Aug/28/2013

errata_c17611_9

S1C17 Family Technical Manual Errata

ITEM **I2C Slave Input/Output Pins**

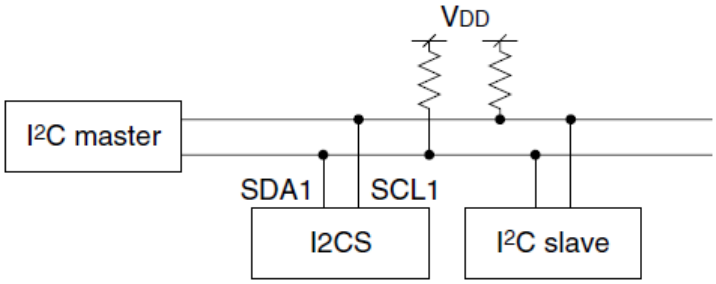
(Addition)

Note: The pins go to high impedance status when the port function is switched. The SCL and SDA pins do not output a high level, so these lines should be pulled up to VDDwith an external pull-up resistor. Be sure to avoid pulling these pins up to a voltage that exceeds the VDD level.

ITEM **I2C Master Input/Output Pins**

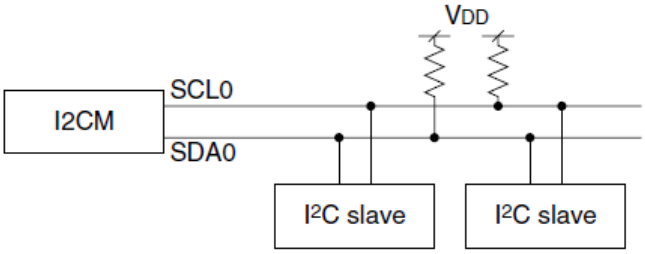
(Addition)

Note: The pins go to high impedance status when the port function is switched.

The SCL and SDA pins do not output a high level, so these lines should be pulled up to VDD with an external pull-up resistor. Be sure to avoid pulling these pins up to a voltage that exceeds the VDD level.

P26-1(S1C17705)

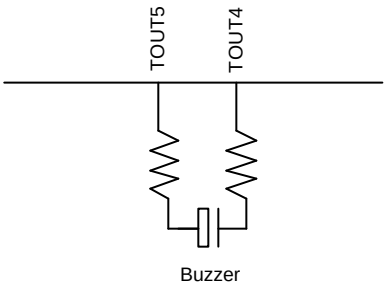
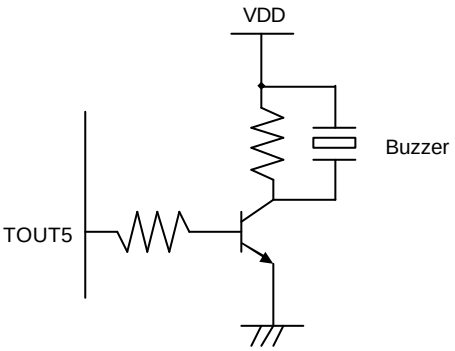
(Error)

(Correct)

P26-1(S1C17711)

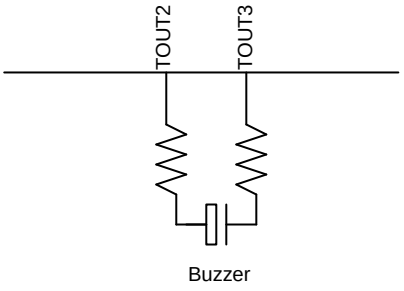
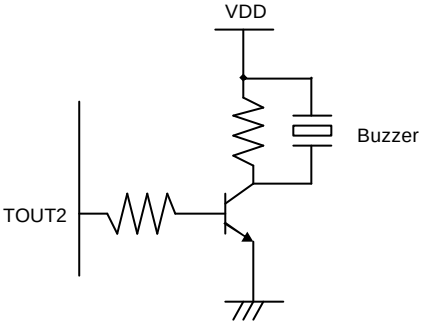
(Error)

(Correct)

P29-1(S1C17121, S1C17601, S1C17611)

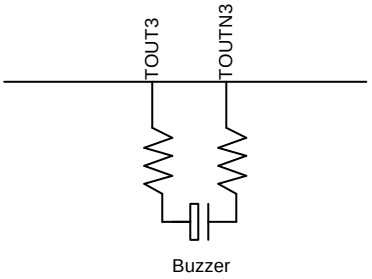
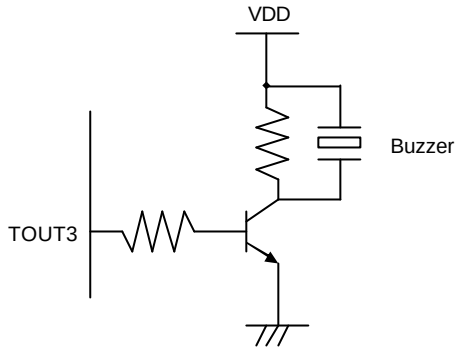
(Error)

(Correct)

P19-3(S1C17602,S1C17121,S1C17702,S1C17003,S1C17601,S1C17611)

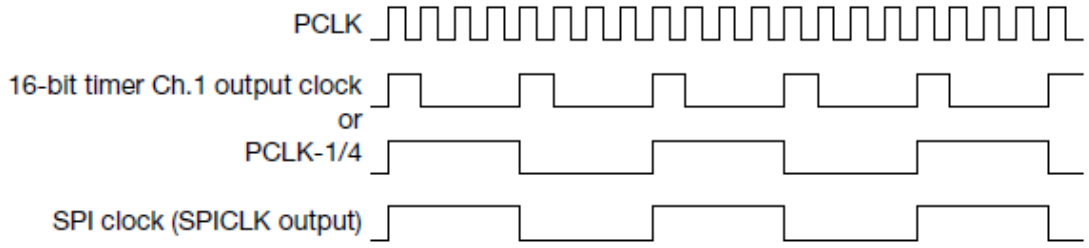
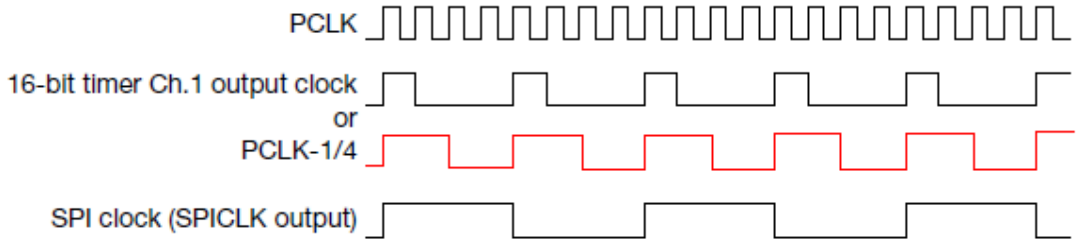
(Error)

The Master mode SPI uses the internal clock output by the 16-bit timer Ch.1 as SPI clock. This clock is output from the SPICLK pin to slave device while also driving the shift register. Use the MCLK(D9/SPI_CTL register) to select to use the 16-bit timer ch.1 output clock or PCLK-1/4 clock. Setting MCLK to 1 selects the 16-bit timer Ch.1 output clock; setting to 0 selects to 0 selects the PCLK-1/4 clock.

(Correct)

The Master mode SPI uses the internal clock output by the 16-bit timer Ch.1 as SPI clock. This clock is output from the SPICLK pin to slave device while also driving the shift register. Use the MCLK(D9/SPI_CTL register) to select to use the 16-bit timer ch.1 output clock or PCLK-1/4 clock is used. Setting MCLK to 1 selects the 16-bit timer Ch.1 output clock; setting to 0 selects to 0 selects the PCLK-1/4 clock.

Figure 15.3.1 Master Mode SPI Clock

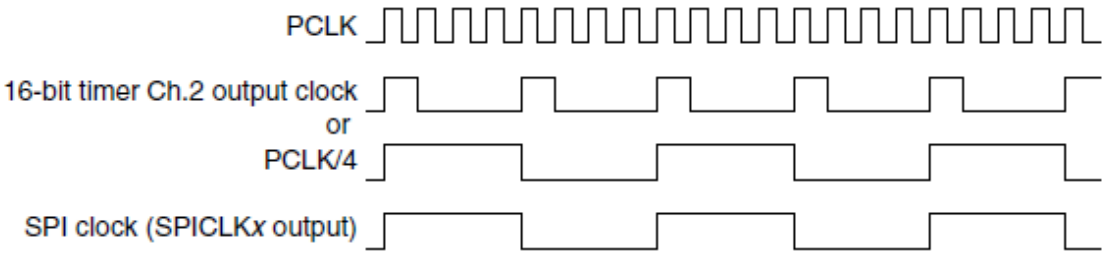
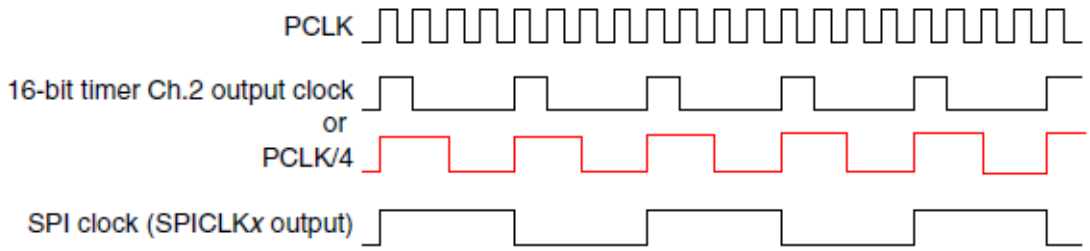
(Error)

(Correct)

Figure 19.3.1 Master Mode SPI Clock

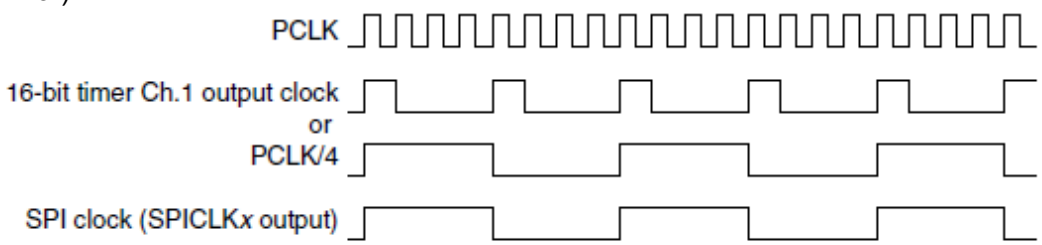
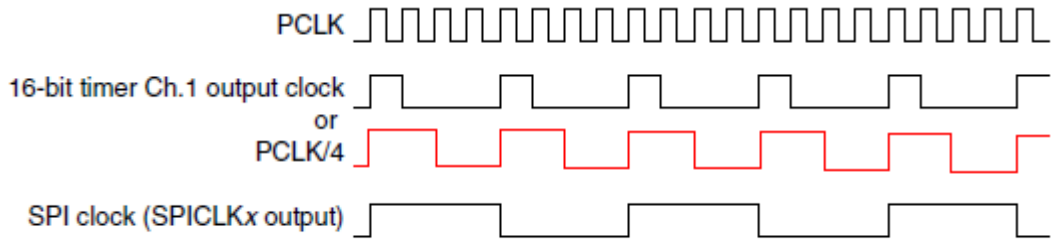
(Error)

(Correct)
